Our Ref: JH/11441/jj

20 August, 2021

**RE: PROPOSED WAREHOUSE AND CUSTOMER FULFILMENT CENTRE,
74 EDINBURGH ROAD, MARRICKVILLE (SSD-10468)**

**20.0m ARTICULATED
 VEHICLE SWEEP PATHS**

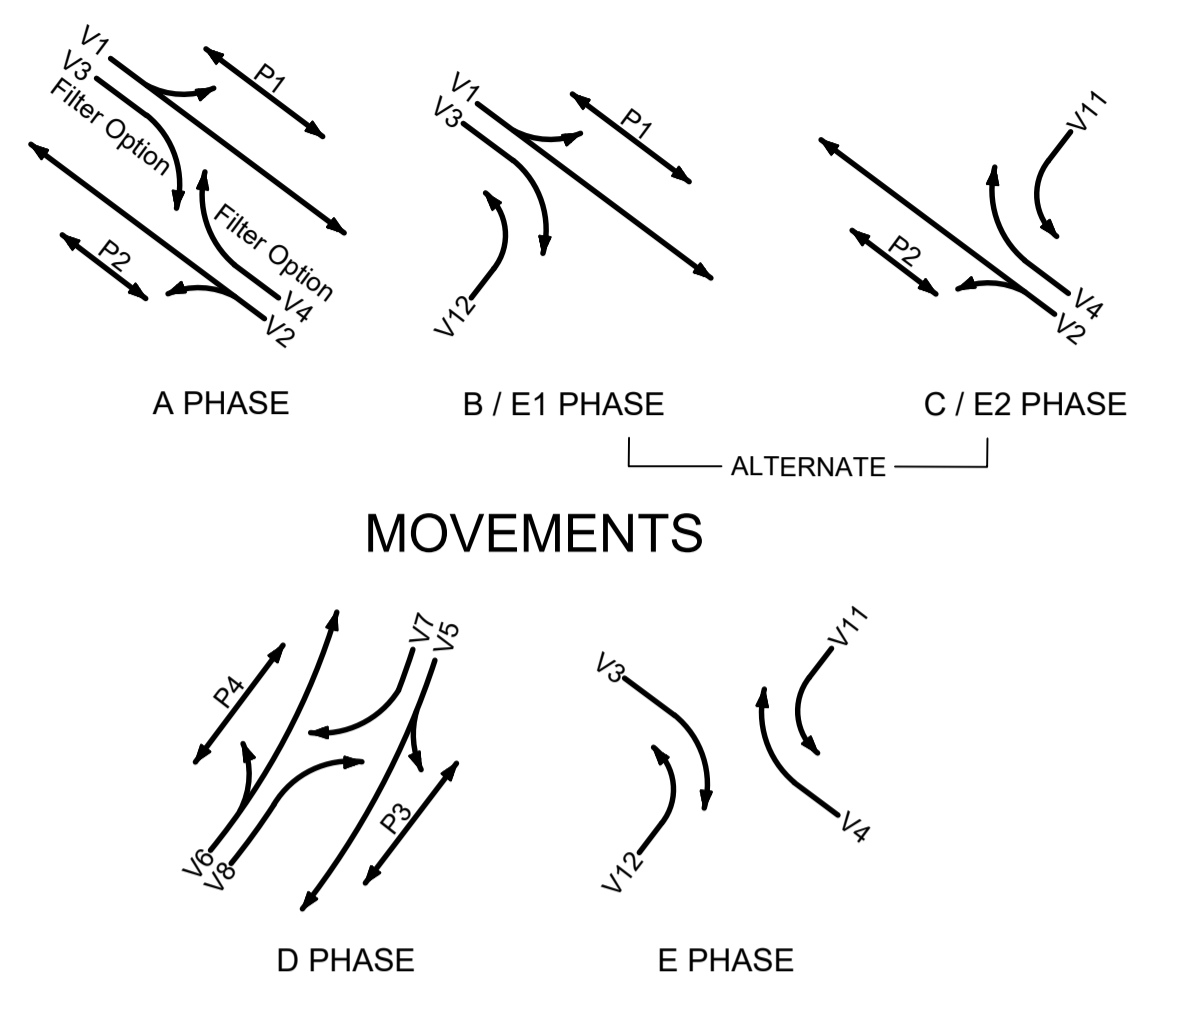
TfNSW has reviewed the internal swept paths for the site and notes that the semi-trailer movement (Sheet 9 in the TIA) is only illustrating the end docking space being utilised. For the other seven loading dock spaces to be utilised, TfNSW believes that the movements may encroach on the car parking spaces.

Recommendation:

13. The western-most dock was included as this is the most constrained in terms of manoeuvring area. Semi-trailers will be able to access all docks, as shown in the attached Figure 1.

INNER WEST COUNCIL AREA
TRAFFIC SIGNALS AT EDINBURGH ROAD
AND SMIDMORE STREET,
MARRICKVILLE

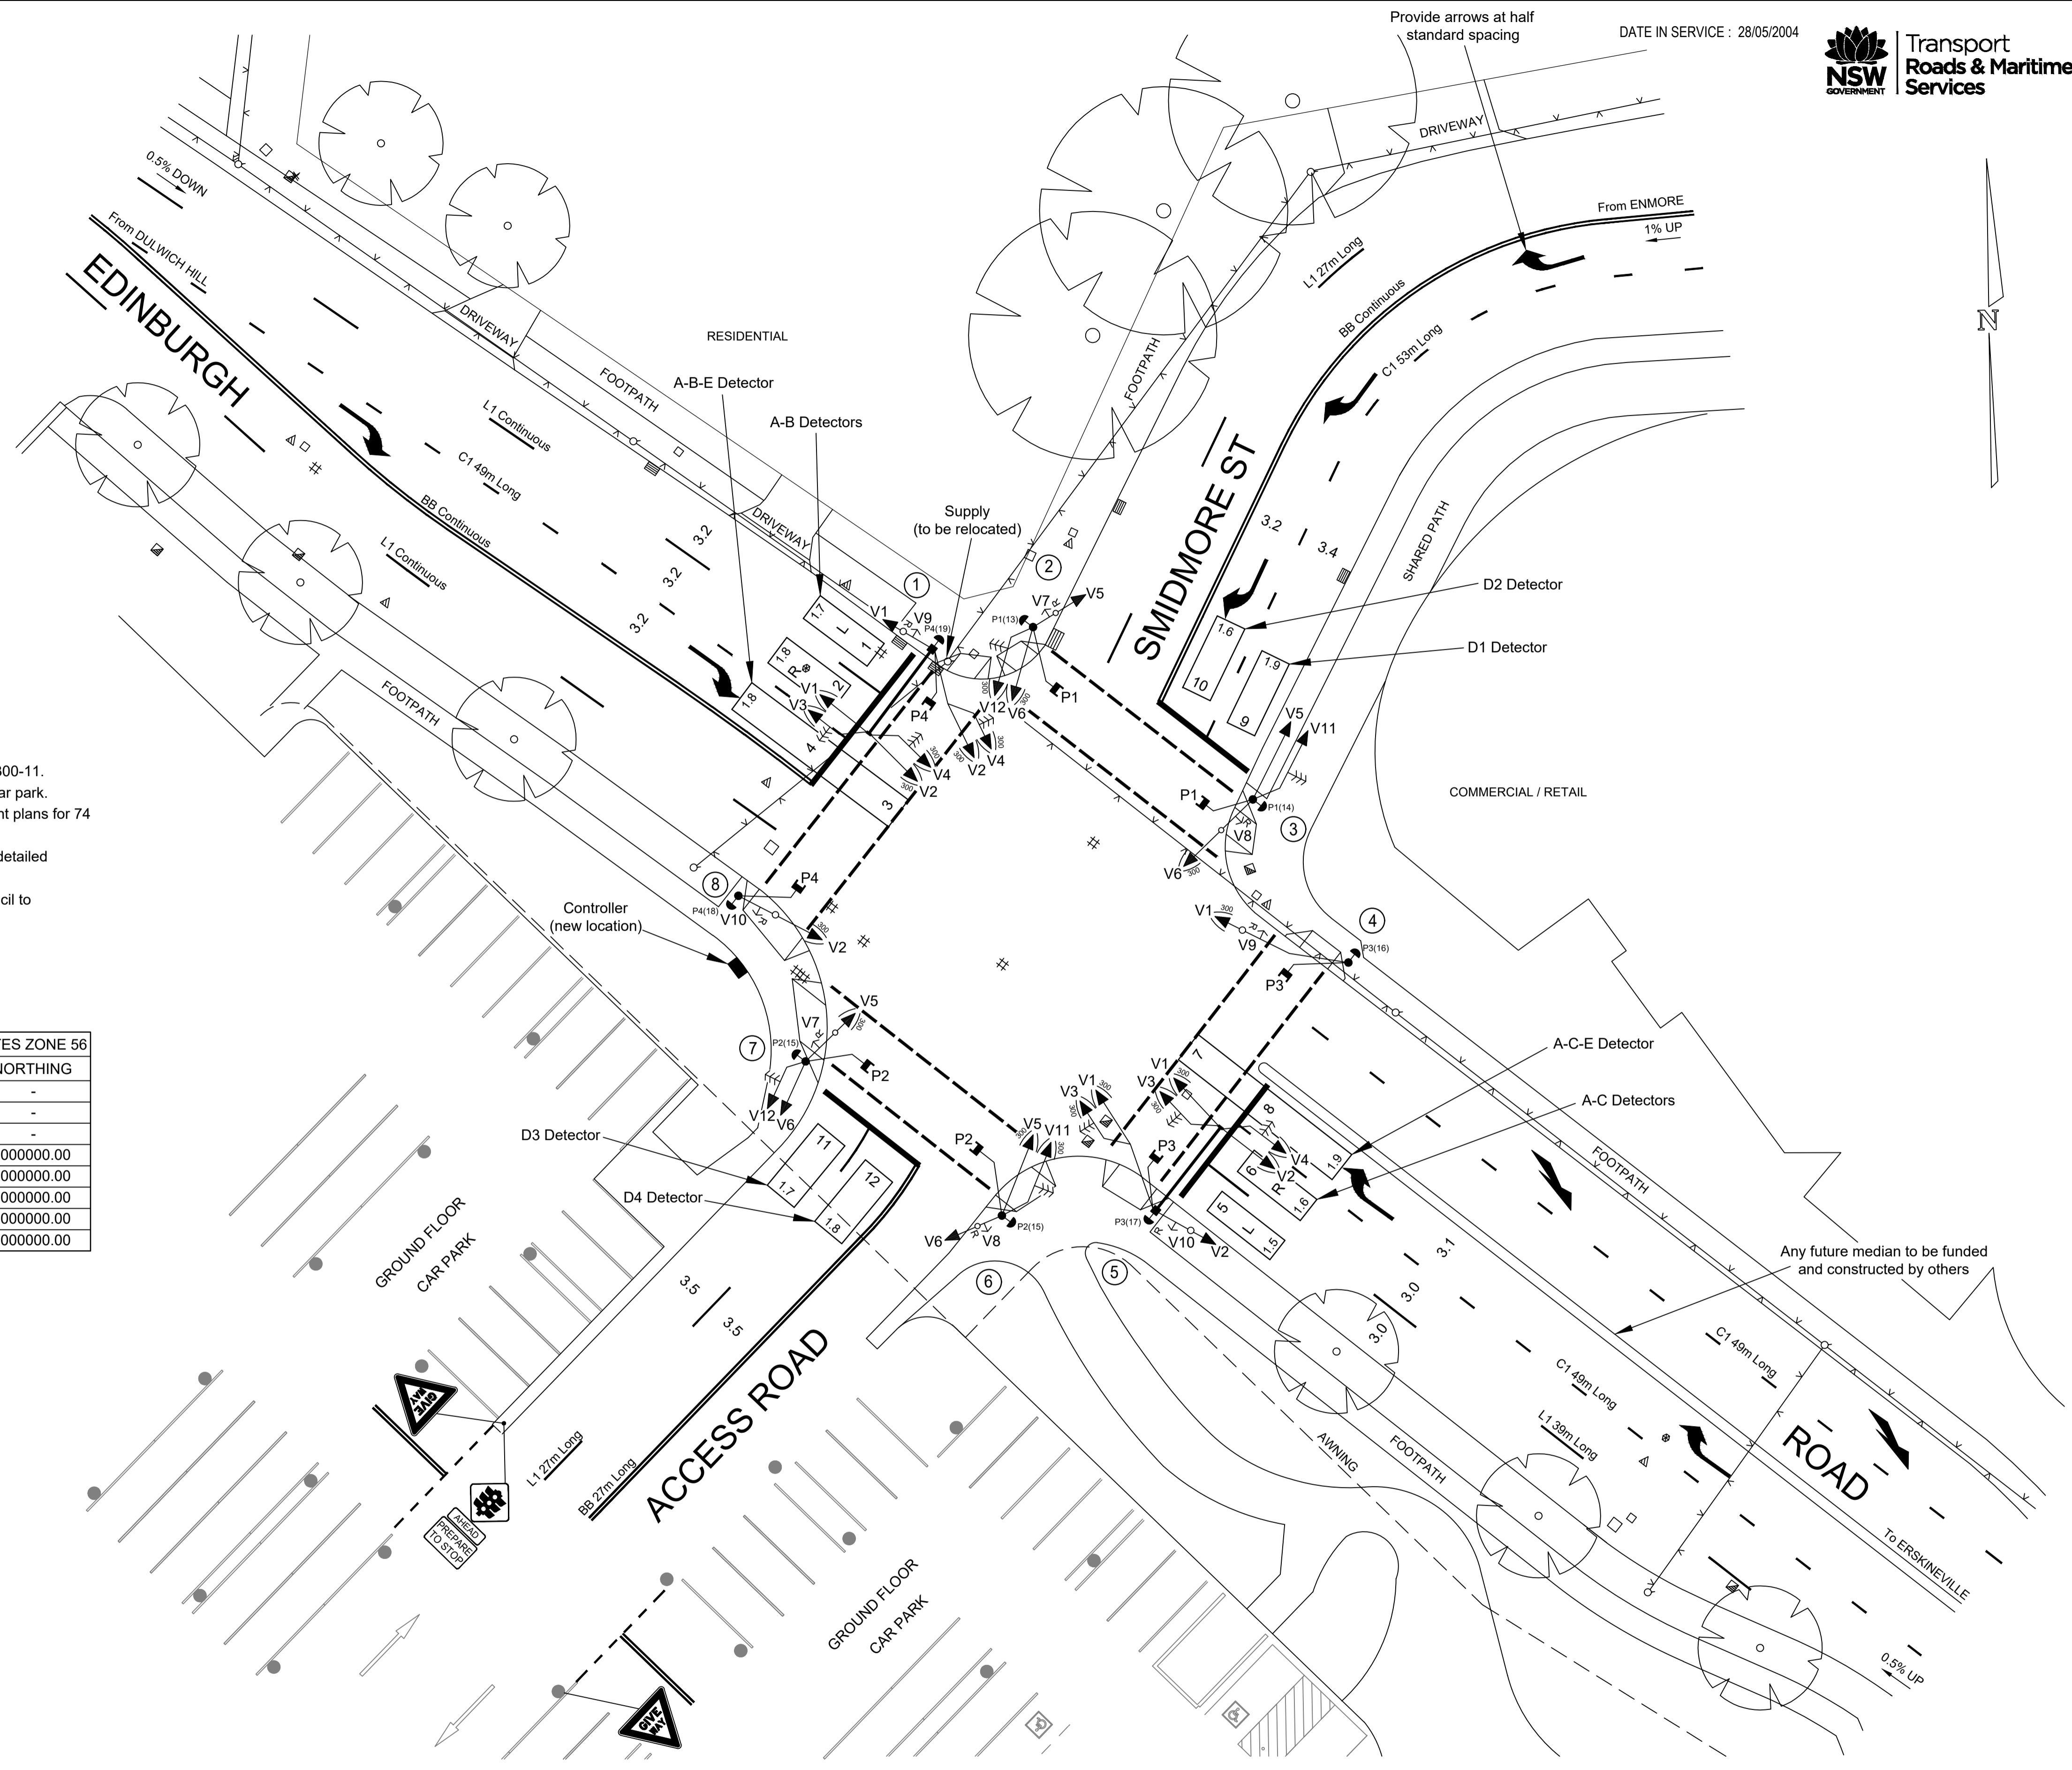
- *In regards to the TCS design plan file name “VV3769_XA_R3” – the right turn bay arrangement will cause significant confusion to motorists and is a major safety concern particularly when a vehicle wants to turn right into the driveway and the vehicles behind wants to turn at the signals. This would cause frequent lane changing with a very short distance, resulting in potential increase in side swipes and rear ends. This proposed right turn bay layout would require two separate right turn bays and within a short distance of less than 50m, it is not possible and is considered unsafe and extremely inefficient.*

- *Layout shows 65m kerb side lane on eastern approach of Edinburgh Rd. Proposed TCS design plan shows approx.. 40m. – Could you please check TCS 3769 bay lengths. It appears they are the wrong way around.*

- *Layout shows 65m on departure side of Edinburgh Rd (eastern leg). Proposed TCS design shows 50m on departure side – Could you please check TCS 3769 bay lengths. It appears they are the wrong way around.*

- *In regards to the TCS design plan file name “VV3769_XA_R3” – the right turn bay arrangement will cause significant confusion to motorists and is a major safety concern particularly when a vehicle wants to turn right into the driveway and the vehicles behind wants to turn at the signals. This would cause frequent lane changing with a very short distance, resulting in potential increase in side swipes and rear ends. This proposed right turn bay layout would require two separate right turn bays and within a short distance of less than 50m, it is not possible and is considered unsafe and extremely inefficient. The safety concerns outlined above have not been addressed.*

- *Discrepancy in phasing between the proposed TCS design plan and SIDRA model for Edinburgh and Smidmore St intersection. Note that proposed TCS design plan has 5 phases whereas SIDRA model shows 7 phases. **Please clarify.***
- *Based on the phasing provided in the TCS design plan, the site in future will operate the following phase sequence: A, D, E, A. **Please amend modelling to reflect this.***

39. This matter relates to whether or not a median is provided in Edinburgh Road which is addressed above in paragraph 27.
- *As previously advised, TfNSW is concerned regarding the complexity of the proposed signalised intersection to include additional phases that would result in queues extending back towards Edinburgh Road / Sydney Steel Road. As such, TfNSW the proposed right turn movement from the west is to be prohibited to mitigate impacts on the surrounding road network and the site would be able to access from the western approach via a roundabout past the site.*

45. The SIDRA modelling includes these amendments.

49. The amended SIDRA modelling includes this phasing.
